**STORE PROPERTY INVESTMENTS LTD
LAND WEST OF BROOK LANE AND
SOUTH OF A259
RUSTINGTON**

**ROAD SAFETY AUDIT RESPONSE
REPORT
STAGE 1 - ROAD SAFETY AUDIT**

JUNE 2018

scale	1:500@A3	drawn by	OAN	checked by	VL
date	JUNE 2018	cad file	Master 2018-06-06.DWG		
drawing number	SPRUST(BROOK LANE).1/10				rev. A

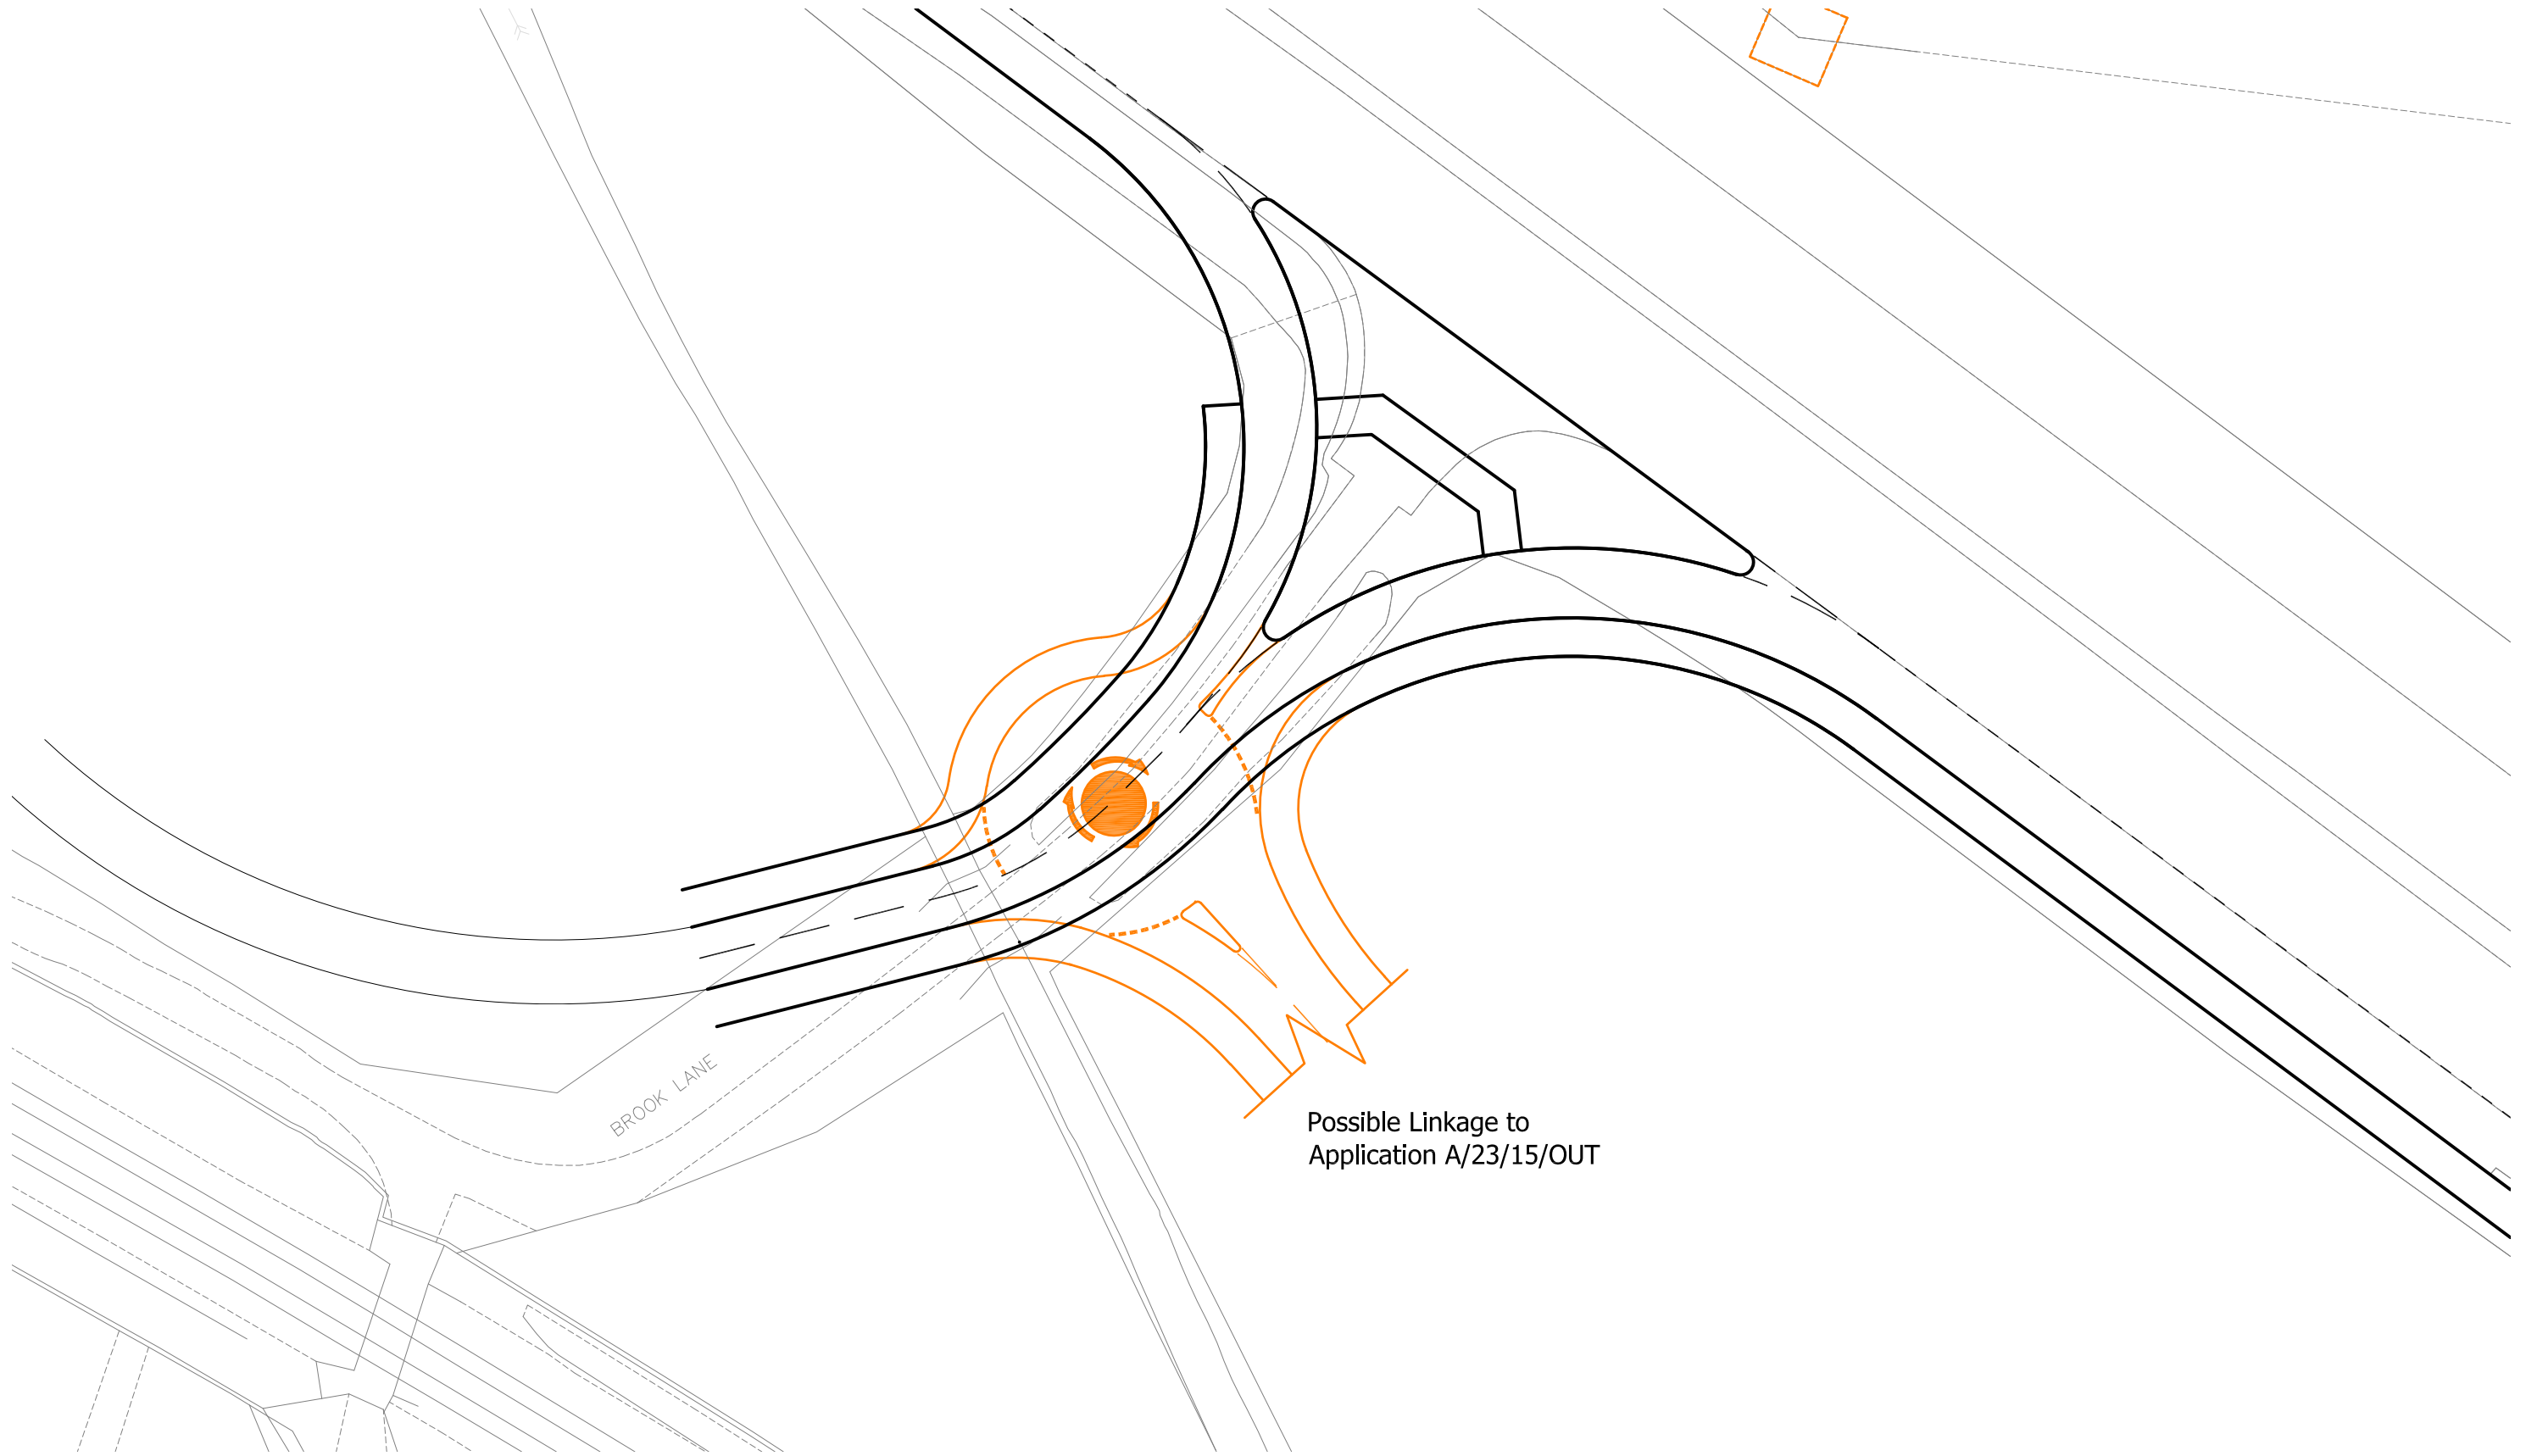
It is unclear at this stage whether the proposed footway on the southside of the A259 will tie-in with the existing retail facilities to the east of the development site. The retail facilities include a foodstore which is likely to attract pedestrian movements between the development site and the aforementioned retail facilities. It is important to ensure that

pedestrians are able to access the retail facilities without traversing the grass verge or stepping into westbound through lane of the A259.

Provide footway continuity linking the site and the retail facilities located further east.

This is agreed, drawing SPRUST(BROOKLANE).1/10A included at **Appendix A** shows a 3m footway/cycleway along the southern side of the A259 linking to the retail developments to the east.

scale	1:500@A3	drawn by	OAN	checked by	VL
date	JUNE 2018	cad file	Master 2018-06-18.DWG		
drawing number	SPRUST(BROOK LANE).1/11				rev.

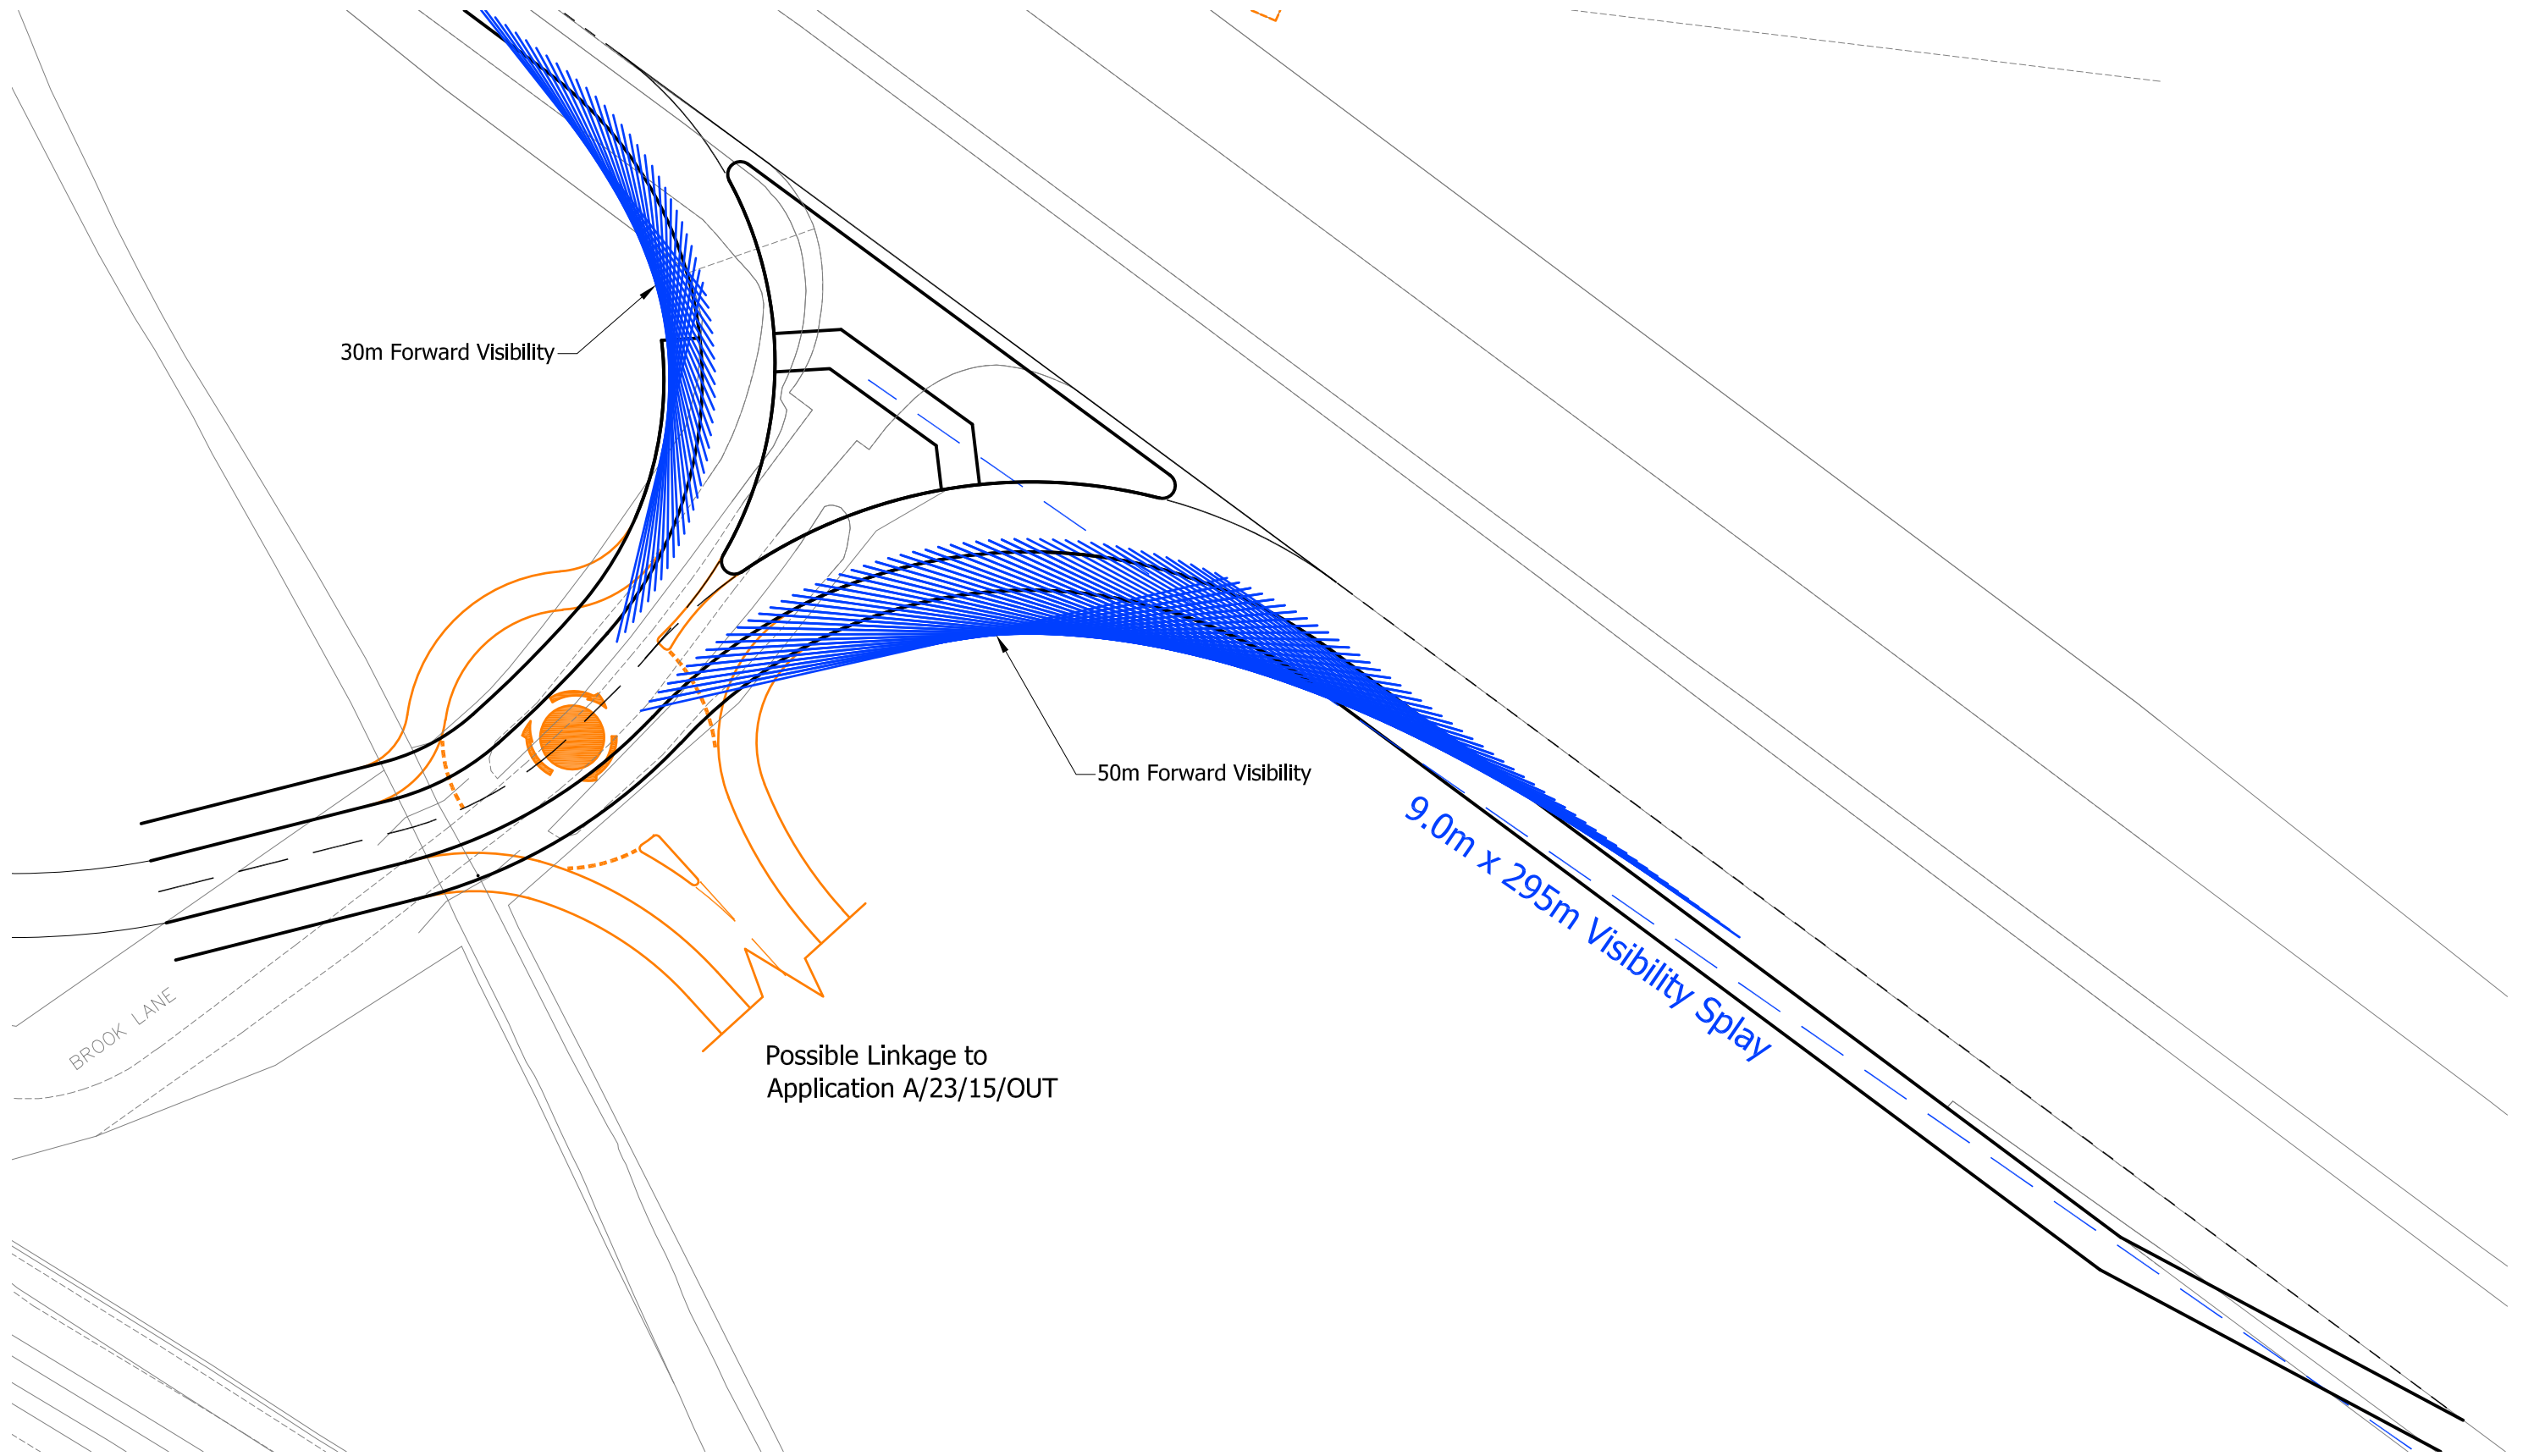
Visibility splays have not been formally identified on the drawings submitted at this stage. It will be important that adequate splays are provided, this should include junction, pedestrian inter-visibility and forward visibility splays.

It was noted during the site inspection that junction and forward visibility splays could be obstructed by existing vegetation.

Provide visibility splays in accordance with relevant design standards and ensure that the splays will be kept free from obstruction. Any vegetation within the splays should be maintained to ensure that it does not extend beyond a vertical height of 0.6m. It will also be important that appropriate visibility is provided to all pedestrian crossing landing points.

This is agreed, visibility splays in accordance with West Sussex County Council approved requirements are shown on drawing SPRUST(BROOKLANE).1/11 included at **Appendix C**.
